**RESPONSE TO ENVIRONMENTAL PROTECTION
AGENCY'S DRAFT NPDES PERMIT**

**PSNH MERRIMACK STATION
UNITS 1 & 2
BOW, NEW HAMPSHIRE**

**Prepared for
Public Service Company of New Hampshire**

February 2012

Figure 1: Spacing Criteria for Johnson CWW Screens [Ref. 6.19]

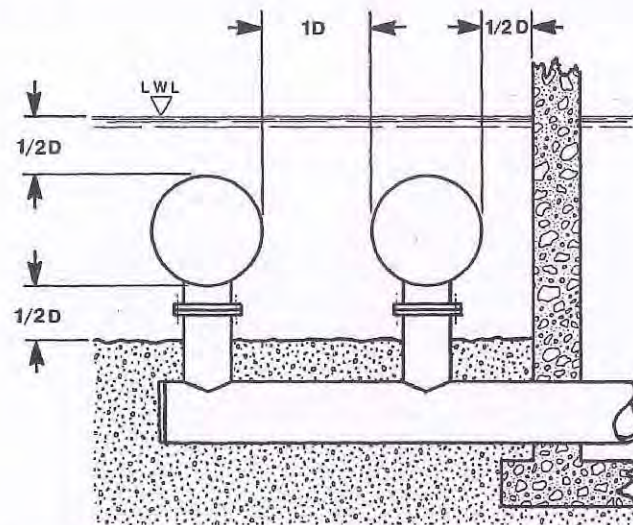
In the draft permit, EPA also concludes that the Merrimack River is too shallow for CWW screens. The 2009 Report [Ref. 6.2] indicated that a CWW screen diameter of 24 inches was chosen for the design of Merrimack Station to take into account the mean low water level of 4 ft. Correspondence with Johnson Screens, the leading CWW screen manufacturer, indicates that one half diameter of clearance must be provided above and below the outer edge of the screen [Ref. 6.2]. The Product Application Guide from Johnson Screens [Ref. 6.19] also gives this spacing requirement, shown in Figure 1. For a 24-inch diameter screen, this signifies a requirement of one foot of water above the top of the screen, and one foot of water between the bottom of the screen and the bottom of the river. Therefore, 24-inch diameter CWW screens can be designed to operate in as little as 4 ft of water.

The 2009 Report presented a preliminary layout of CWW screens. This preliminary layout showed CWW screens being installed from approximately 60 ft to approximately 95 ft offshore in front of the existing Unit 1 and 2 screen houses [Ref. 6.2]. As discussed in the 2009 Report, the mean low water level in the vicinity of the CWW screens is 4 to 6 ft, with an average depth of 6 to 10 ft. Crude bathymetry data provided by Normandeau for the lower Hooksett Pool demonstrated water depths of approximately 7-15 ft along this transect in the region closest to where the CWW screens would be installed (Attachment 1, Section 2). This data is obtained from the N-5 transect, located just south of the intake structure [Ref. 6.11]. More detailed bathymetry data would be necessary to confirm the depths of the river in this area, but currently available data suggests that water depth would not be an issue for a 24-inch diameter CWW screen installation.

Figure 3: Existing Open-Cycle Cooling Flows at Merrimack Station

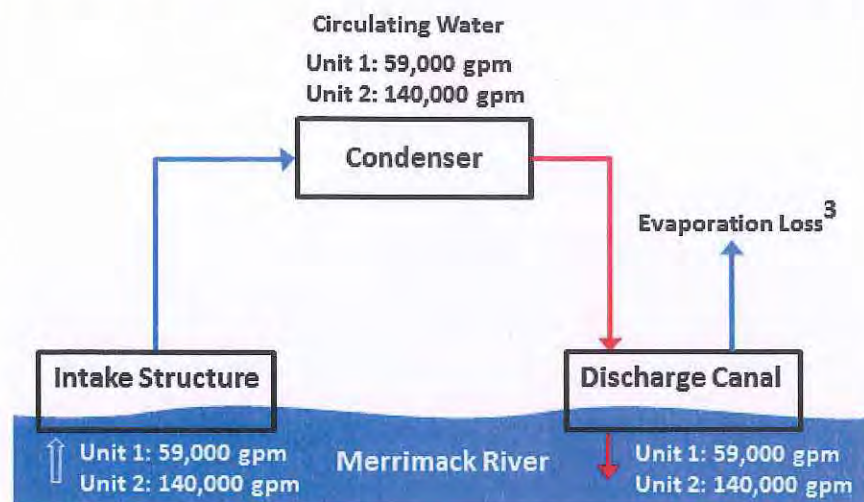
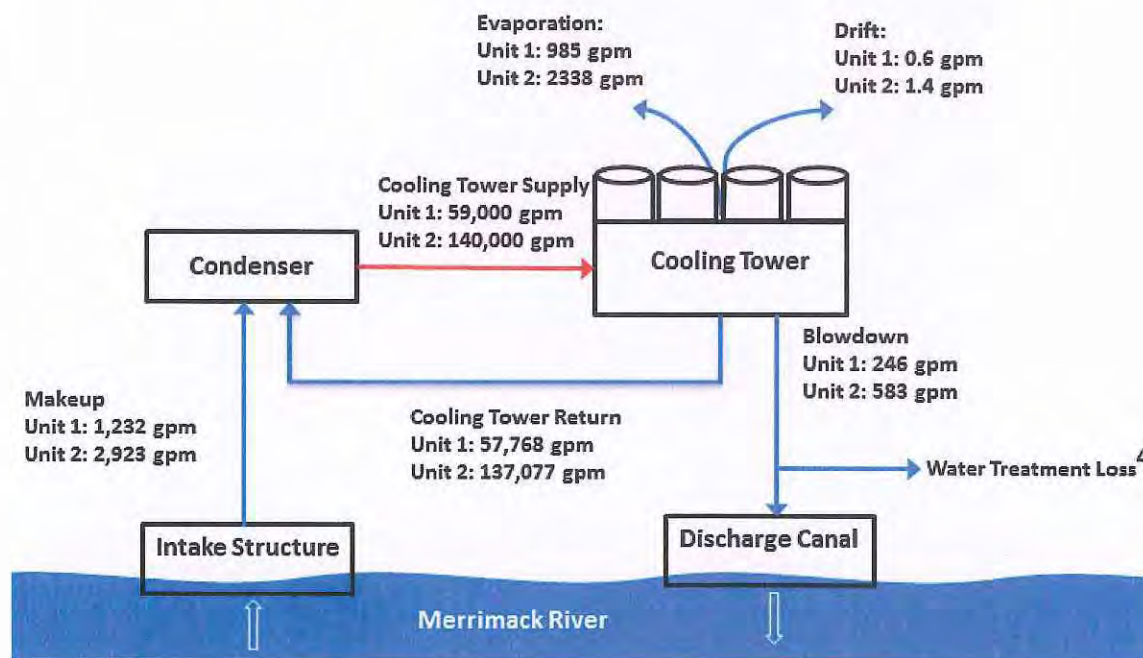
In the draft permit, EPA states that the PSNH estimation of the impact of additional evaporation upon the Merrimack River errs on the high side because it does not take into account evaporation already occurring in the existing cooling system. Although this statement is technically correct (the evaporation resulting from operation of the current system was not included in the estimation), the current cooling system evaporates only a very small amount of water, especially when compared to the evaporation that would occur using a wet or hybrid cooling tower. Unlike cooling towers, the primary mechanism by which the PSMs cool water is convection, and not evaporation. Additionally, the existing

The 2007 Response indicated that evaporation loss from the Hooksett Pool due to a cooling tower was a concern. It was estimated that the total loss of river water due to installation of a cooling tower would be 4.79 million gallons per day. This represents a significant loss of water from the Hooksett Pool daily. While small compared to evaporation losses, the water loss from cooling tower drift could still represent measurable water losses over time. According to SPX Cooling Technologies (SPX) "Cooling Tower Fundamentals" [Ref. 6.8], drift rate can be estimated by multiplying the total water flow rate by 0.02%. Given a total combined flow rate of 199,000 gpm for Units 1 and 2, this represents over 57,000 gallons per day of additional water lost from the Hooksett pool. Using state-of-the-art drift eliminators, the drift rate of the cooling tower could potentially be restricted to 0.001% of the total water flow rate, reducing the amount of water lost to drift daily to 2,880 gallons per day, as conservatively estimated in the 2007 Response [Ref. 6.3].

Simplified schematics of the closed-loop and open-loop cooling water system configurations are shown in the Figures below; Figure 3 depicts the existing open-cycle configuration, while Figure 4 shows a potential closed-cycle configuration. It is estimated that the closed-cycle cooling system would consume approximately 3,325 gpm of water. This amount of water loss is equivalent to approximately 2,640 Olympic-sized swimming pools per year [Ref. 6.21]. Note that several smaller miscellaneous loads (e.g., slag sluice, de-icing recirculation, travelling screen wash, equipment cooling, fire water, etc.) are not included in the schematic diagrams below for simplicity.

It is important to note that while a closed-cycle cooling system draws significantly less water from the river than an open-cycle cooling system, it consumes significantly more
